UNITED STATES PATENT AND TRADEMARK OFFICE

10/574,103

Office Action Summary	Application No. 10/574,103	Applicant(s) DOMOLATO, MAURIZIO	
	Examiner JEREMY C. RAMSEY	Art Unit 3634

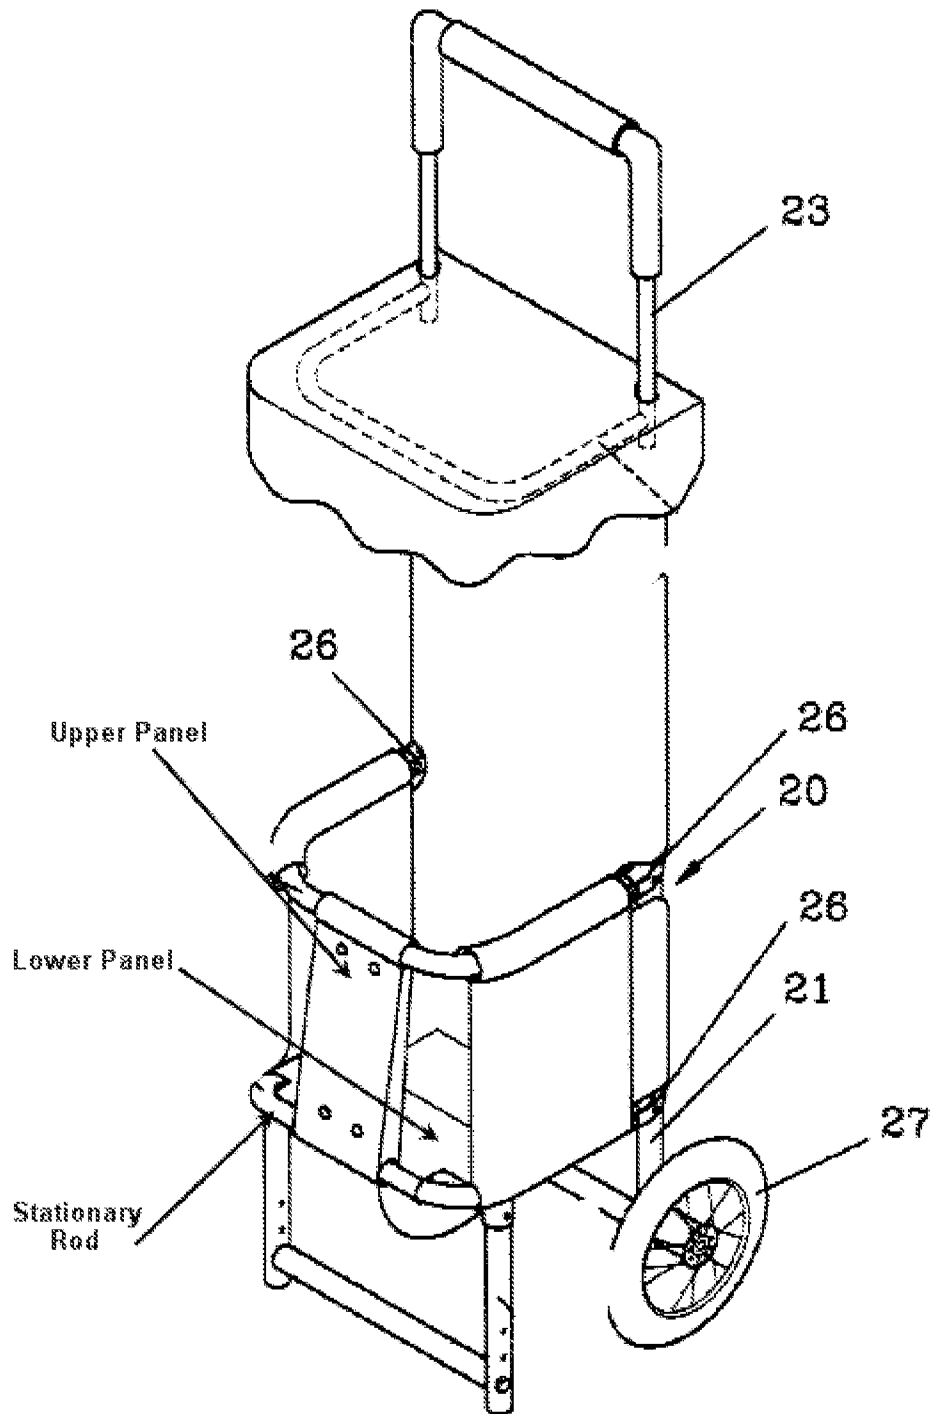
In re claims 11,23 and 26, with reference to Figures 3-5, Lin '713 disclose a vertical structure having both functions as a seat in a first positions and a partition in a second position comprising:

- A pair of upright supports (11) extending in the vertical position.
- A quadrilateral articulated frame composed of rods (13)(14).
- A lower pair of the rods (left and right sides of 14) hinged to the upright supports (11) at a lower part and an upper pair of the rods (left and rights sides of 13) hinged to the upright supports (11) at an upper part.

- The lower and upper pairs of rods oriented perpendicular to the upright supports (11).
- An upper panel and lower panel attached to the frame, said frame adapted to allow the vertical structure to act as a seat with the lower and upper rods (13)(14) of the frame oriented perpendicular to the upright supports (Figure 5) and as a partition screen with the rods and the upright supports coinciding and the upper panel and the lower panel being coplanar. (dashed lines in Figure 4)

- The upper panel being a seat backrest and the lower panel being a seat bottom.
- Connecting parts (12) moving the frame, upper panel and lower panel between a first position with the lower panel providing a seat and the lower rods (13) perpendicular to the upright supports (11) and a second position with the upper panel and lower panel positioned vertically with the upper and lower pairs of rods (13)(14) coinciding and the vertical plane defined by the upper panel and lower panel being coplanar. (Figure 4)

- Wherein the frame has end stops (12) mounted to the rods (13)(14) which abut against the upright supports (11) when the seat position is reached.
- Wherein the rods are hinged to the vertical structure by pins (121) and the upright supports (11) remain vertical and non-displaced during operation while the frame is displaced between a first configuration acting as the seat and a second configuration acting as the partition screen.

- The lower rods (left and right sides of 13) are hinged with a stationary rod connected transverse to the upright supports (11). (shown above)
- Wherein the panel is a single piece secured between the rods and the stationary rod.

- Wherein the panel may be made of materials adapted to withstand the weight of a person. (inherently so, since the device serves as a chair)
- Wherein when the vertical structure is configured as a seat (first position) the upper panel is vertical to the lower panel and the upper panel is facing and completely spaced apart from the upright supports (11) by an upper pair of the rods (14) and a lower pair of the rods (13) extending away from the upright supports (11).
